Appeals Convenor's Report to the Minister for Environment

Appeals objecting to report and recommendations of the EPA
Report 1664 Scarborough Project – Nearshore Component

Appellants	Conservation Council of Western Australia (Inc) Deep History of the Sea Country Project Team
Proponent	Woodside Energy Limited
Authority	Environmental Protection Authority (EPA)
Appeal No.	002 of 2020
Date	June 2021

Figure 2 – Palaeobeach formation, northern Mermaid Sound (Source: Woodside, 2020)

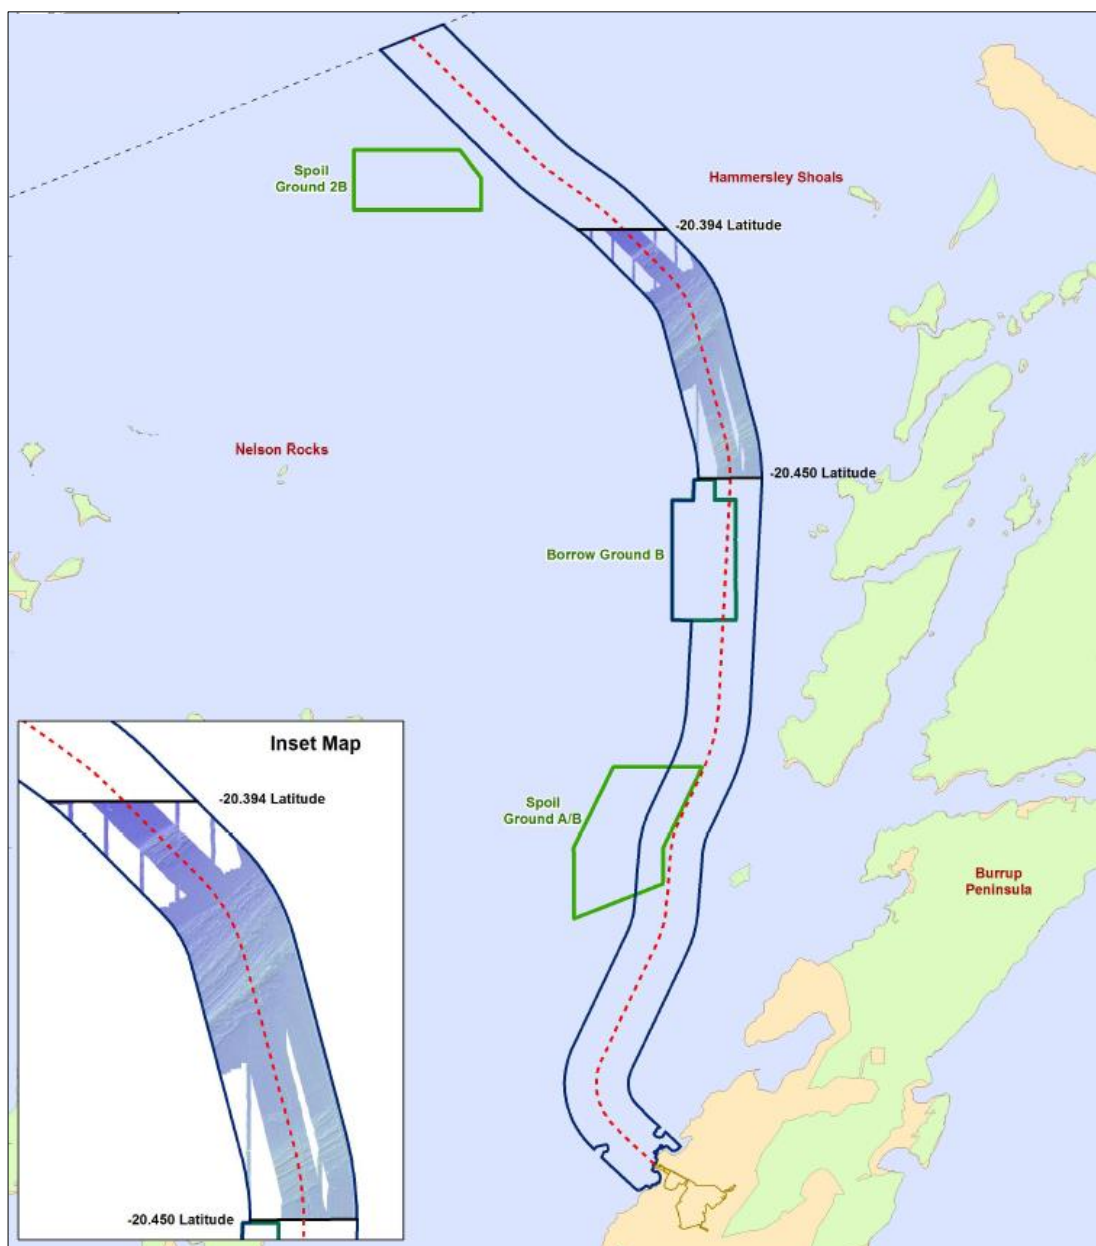
A final version of a possible change to condition 7-1(1)(d) was developed as follows (new text underscored):

- (d) disturbance of areas of volcanic rock in the sea bed and to those areas of the submerged paleobeach formations that extend across the northern entrance to Mermaid Sound between Nelson Rocks and Hamersley Shoals (that are exposed in isolated sections) and that are bounded approximately between minus 20.394 decimal degrees south and minus 20.450 decimal degrees south.

Figure 2 shows the location of these coordinates in context with the barrier formations raised by the appeal.

The change to condition 7-1(1)(d) circulated during the appeal investigation preceded receipt of the cultural heritage assessment provided to the Appeals Convenor in May 2021. As noted above, that assessment suggests there is low likelihood for lithic materials being cemented in the palaeobeach formations raised by the appeal.

Because of the above finding, and noting the commitment by Woodside in the current draft of the CHMP to avoid dredging of harder calcareous rock and compact sediments with the potential to preserve archaeological materials, the change to condition 7-1(1)(d) (with a narrow focus on a small section of the proposal length) is no longer considered necessary.
